# TOWN OF UNDERHILL

## Development Review Board

JASON A. & KAREN M. GUYMON AND  
ANTOINE M. & PAMELA J. CATUDAL  
SKETCH PLAN REVIEW  
Docket #: DRB-19-08

<b>Project Proposal:</b>	Sketch Plan Review of Jason A. & Karen M. Guymon and Antoine M. & Pamela J. Catudal for a proposed 2-Lot Subdivision of property located at the aforementioned address.
--------------------------	---

### SECTION 3.18 – STEEP SLOPES

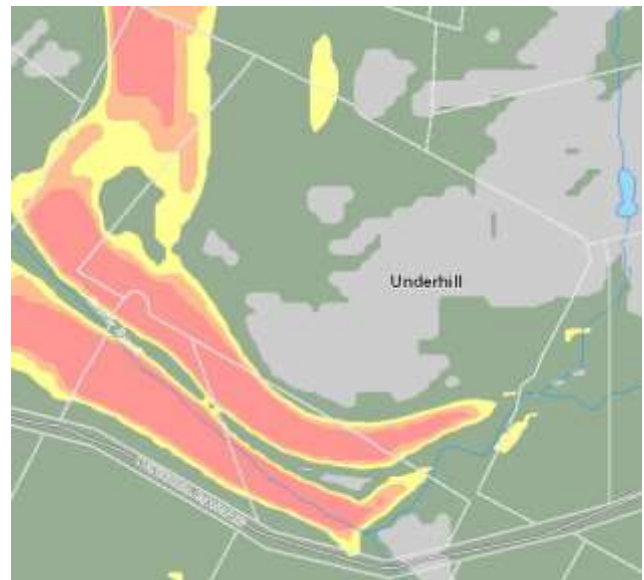
- Areas of steep slopes (15-25%) are present on the existing lot (see directly to the right).
  - Steep Slopes (15-25%) and Very Steep Slopes (>25%) appear to affect both lots; however, the proposed/existing developments (single-family dwellings) appear to be outside of these areas.
- Since both driveways are already constructed, no additional impact to these areas is anticipated.
  - If the Board requires modifications to the existing driveways, then the Board should take slopes into consideration at that time.
